Subject: Findings of No Significant Impact (FONSI) for the  
Honolulu Fire Department Headquarters Complex  
Kaka'ako, Honolulu, Oahu, Hawaii; TMK: 2-1-031:015 and 018

FINAL ENVIRONMENTAL ASSESSMENT

**HONOLULU FIRE DEPARTMENT  
HEADQUARTERS COMPLEX**

Figure 4  
 Site Plan  
**Honolulu Fire Department  
 Headquarters Complex**

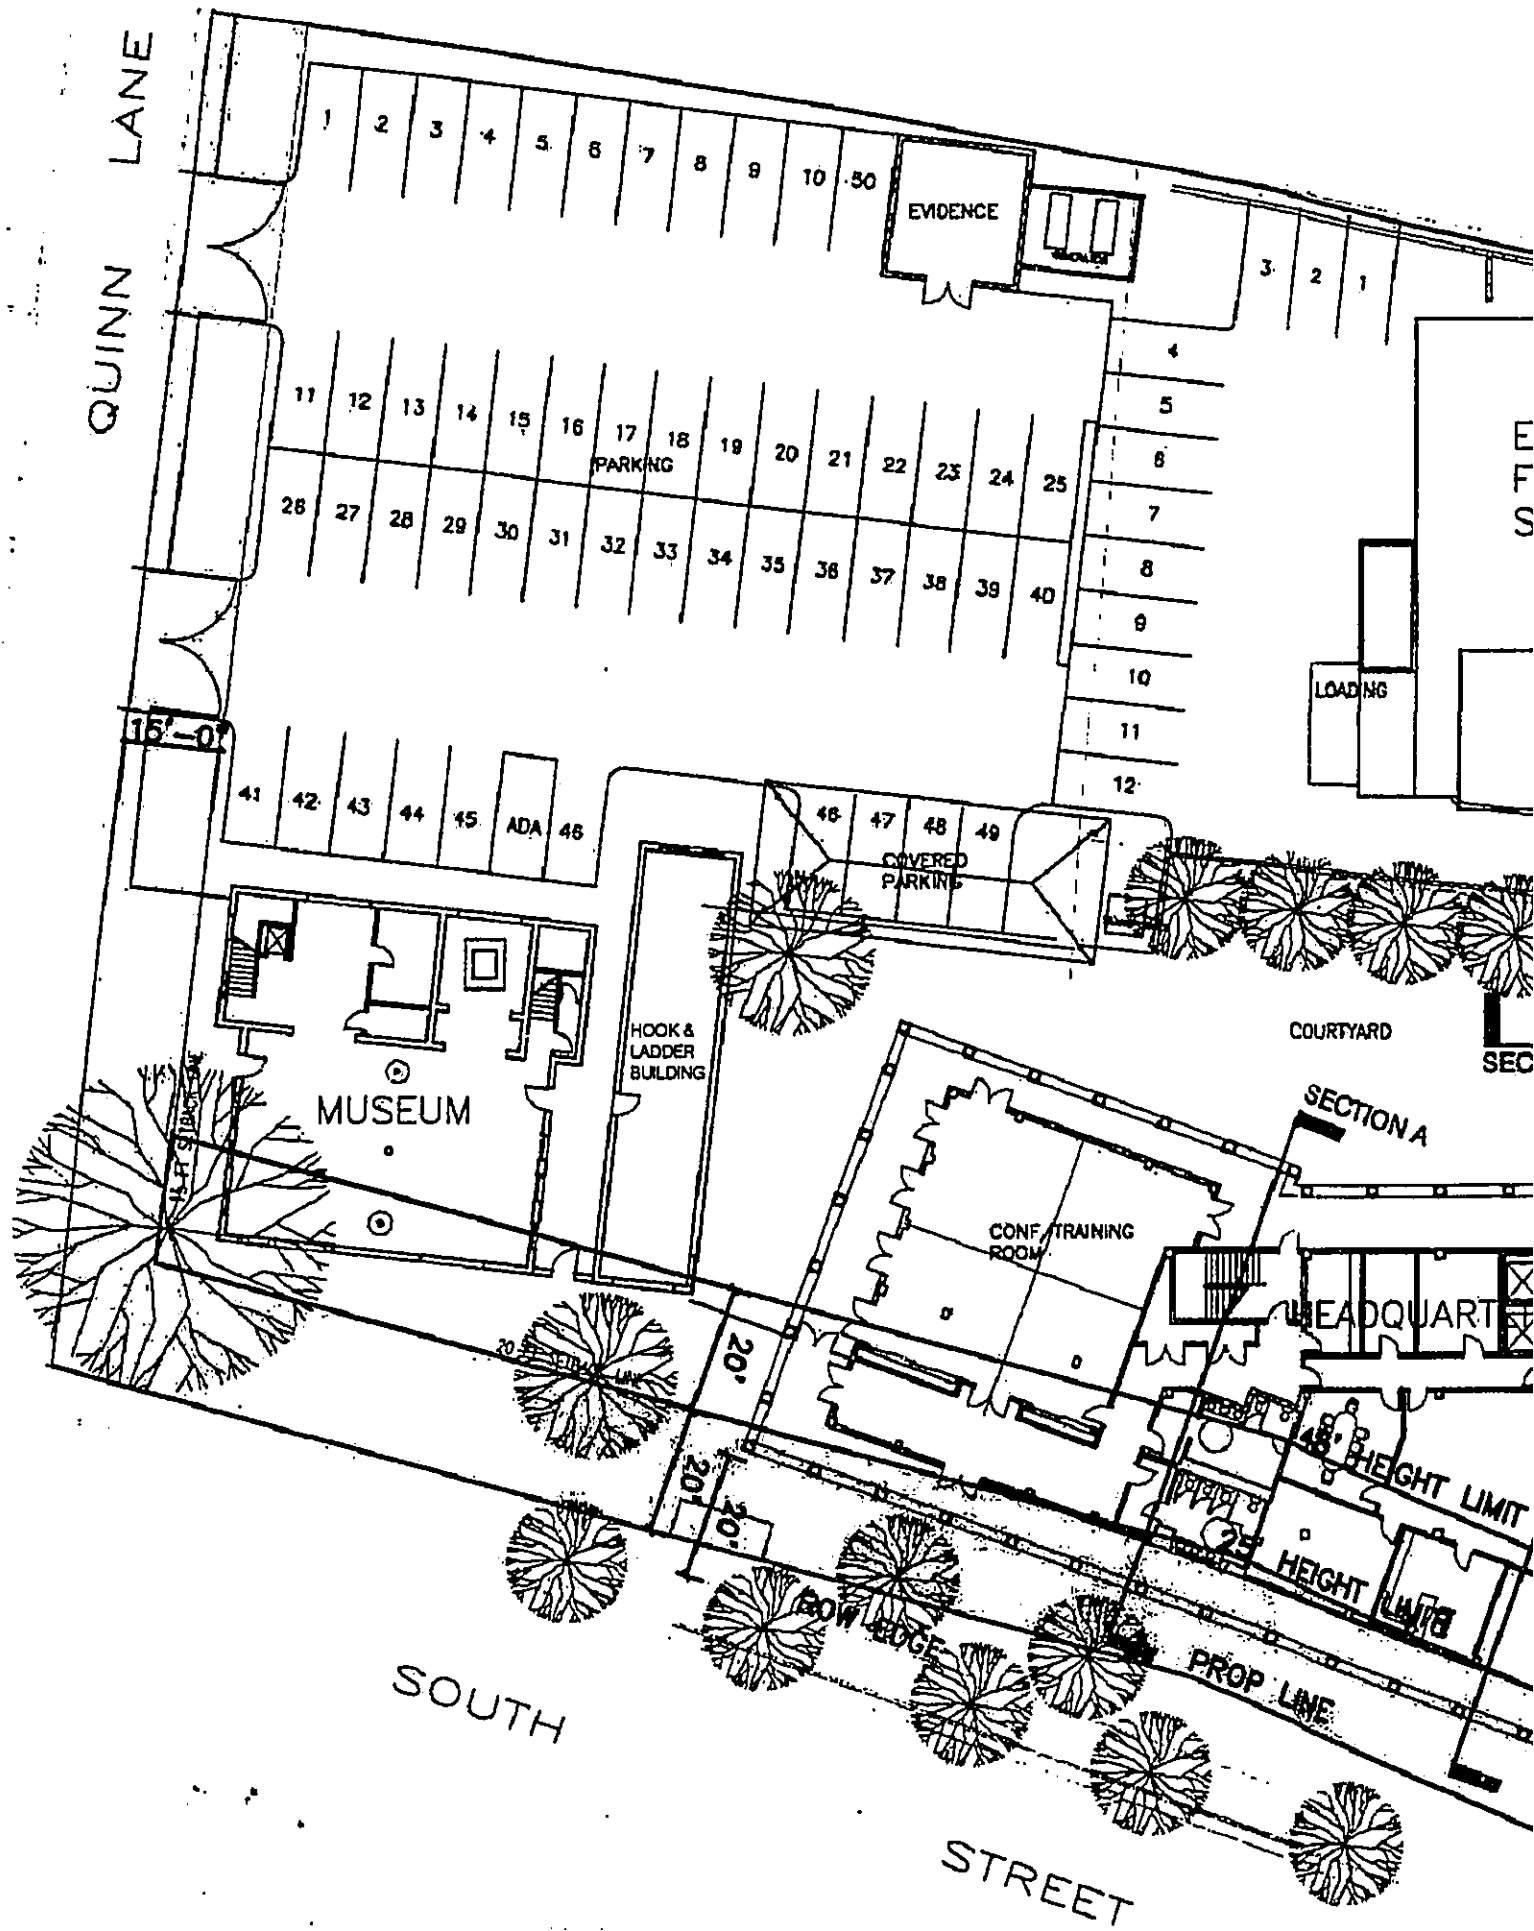
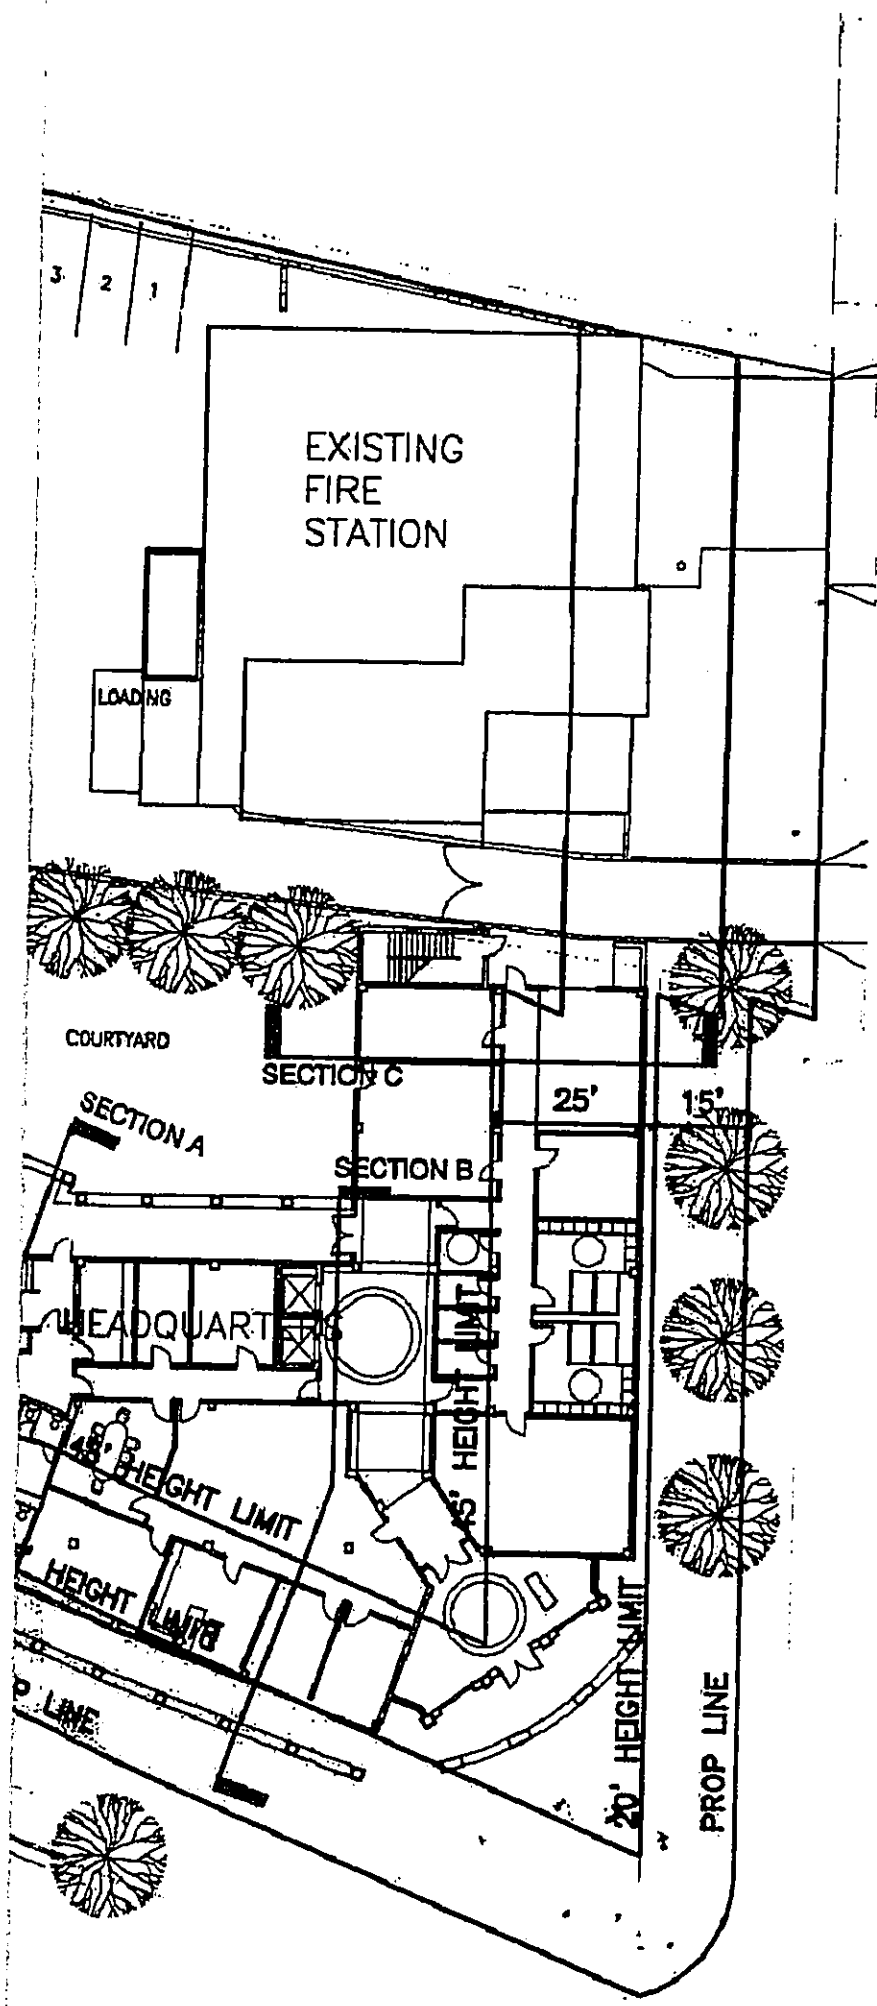
1. The Hook and Ladder Building should be identified on the Preliminary Site Plan.
2. A site plan of "Existing Conditions" should be provided.
3. Section 1(B)4 Maintenance Building and Parking Lot--1<sup>st</sup> Paragraph: Insert the following: "The parking lot will be landscaped with shade trees where such planting will not disturb existing burials."

1. The Hook and Ladder Building will be identified on the Preliminary Site Plan.
2. A site plan of "Existing Conditions" will be included in the Final Environmental Assessment.
3. The paragraph has been reworded as suggested.
4. The paragraph has been reworded as suggested.
5. Landscaping of Parking Lot and Certificate of Appropriateness have been included.
6. A municipal bus stop is located on South Street across Quinn Lane.
7. The paragraph has been corrected as suggested.
8. The paragraph has been reworded as suggested.
